QUALITY ASSURANCE -- NON-CONFORMANCE REPORT

Location: Changxing Island, Shanghai, P.R. China **Report No:** NCR-000601
Prime Contractor: American Bridge/Fluor Enterprises, a JV **Date:** 05-Jan-2010
Submitting Contractor: Zhenhua Port Machinery Company, Ltd (ZPMC), Changxing Island **NCR #:** ZPMC-0574

Job Name: SAS Superstructure

Subject: NCR No. ZPMC-0574

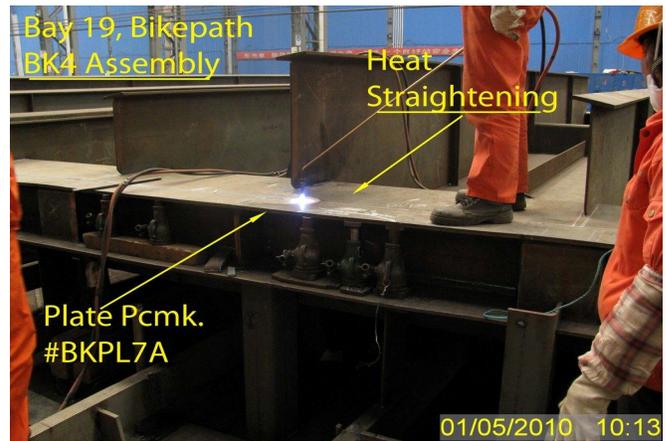
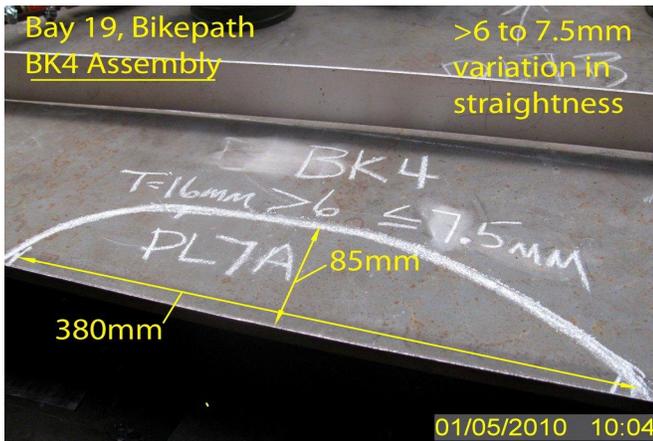
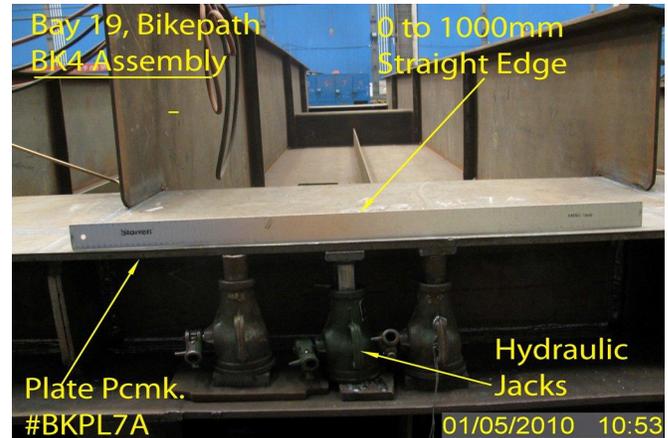
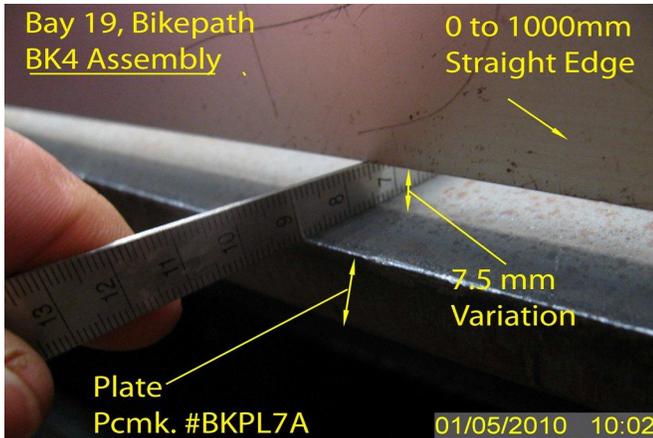
- During the Caltrans Quality Assurance in-process observations of the fabrication of the bike path components in assembly bay 19 this Quality Assurance Inspector (QA) discovered the following issue:
- ZPMC heat straightening an area of material distorted by welding without the Engineers approval.
 - The bike path segment is identified as BK4.
 - The part is identified as BKPL7A.
 - The deviation from flat as measured by this QA was 7.5mm per 1000mm.
 - Material thickness is 16mm.
 - ZPMC QC was not present during the time of the heat straightening process.

AWS D1.5/2002 Section 3.7.3: Members distorted by welding shall be heat straightened by mechanical means or by carefully supervised application of a limited amount of localized heat as approved by the engineer.

Caltrans Special Provisions Section 8-3: For material less than or equal to 16 mm thick, the Contractor shall not heat straighten members more than 6 in 1000 without prior approval of the Engineer.

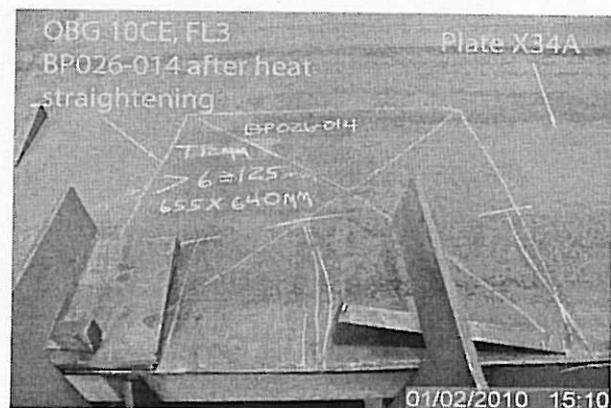
During the Quality Assurance (QA) in-process inspection of the FL3 floor beam bottom plate components, this QA inspector discovered the following issue;

- ZPMC personnel performed heat straightening on OBG segment 10CE, FL3 Bottom Plate without the prior approval of the engineer.

-The Bottom Plate assembly is identified as BP026-014 and the plate is identified as X34A, which measured to be a total of 12.5mm out of straightness in 1000mm.

-ZPMC QC or CWI were not present during the time of the heat straightening process.

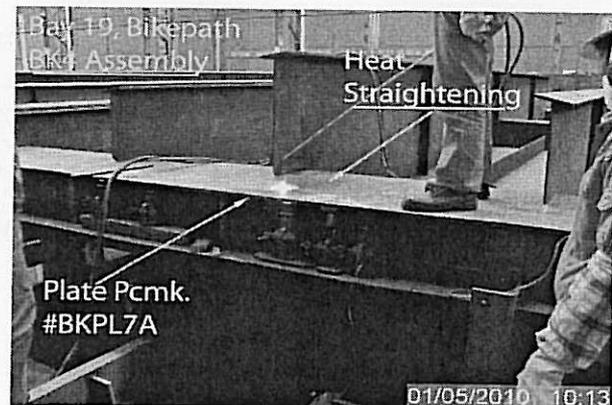
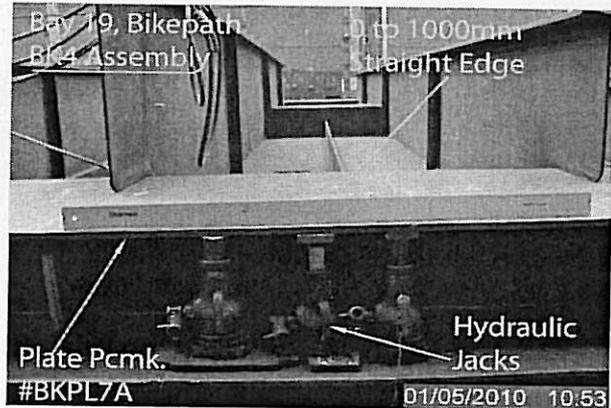
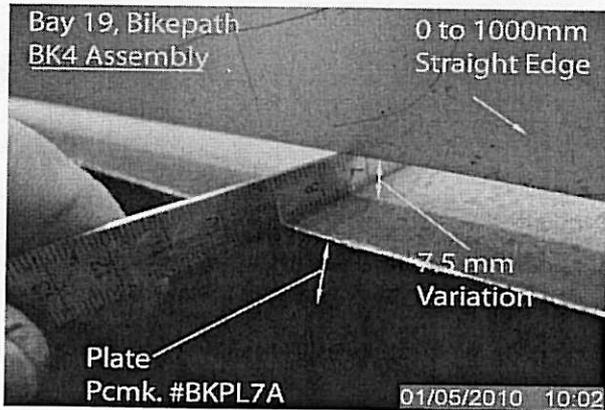
During the Caltrans Quality Assurance in-process observations of the fabrication of the bike path components in assembly bay 19 this Quality Assurance Inspector (QA) discovered the following issue:

- ZPMC heat straightening an area of material distorted by welding without the Engineers approval.
- The bike path segment is identified as BK4.
- The part is identified as BKPL7A.
- The deviation from flat as measured by this QA was 7.5mm per 1000mm.
- Material thickness is 16mm.
- ZPMC QC was not present during the time of the heat straightening process.

AWS D1.5/2002 Section 3.7.3: Members distorted by welding shall be heat straightened by mechanical means or by carefully supervised application of a limited amount of localized heat as approved by the engineer.

Caltrans Special Provisions Section 8-3: For material less than or equal to 16 mm thick, the Contractor shall not heat straighten members more than 6 in 1000 without prior approval of the Engineer.
